Attorney Docket No. 10559-350001
Application No. 09/662,054
Amendment dated December 4, 2003
Reply to office action dated October 6, 2003

Amendments to the Drawings:

Page 1 of 2
Appl. No.: 09/662,054
Amendment in Reply to Office action of October 6, 2003
Renlacement Sheet

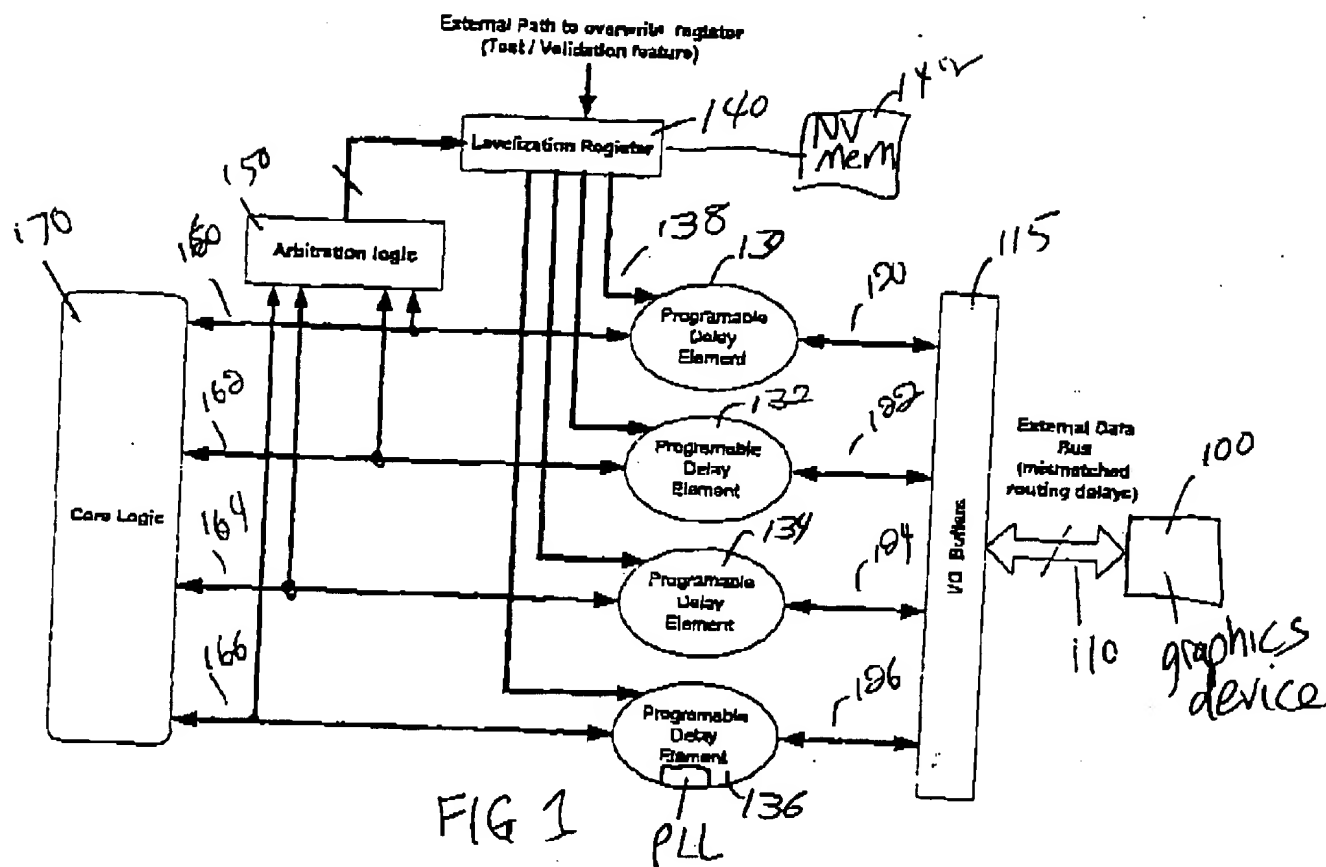
The attached replacement sheet 1 of drawings includes changes to Fig. 1 and replaces the original sheet including Fig. 1.

Figure 1 has been amended to show that the delay elements may be a phase locked loop, and also to show the graphics element.
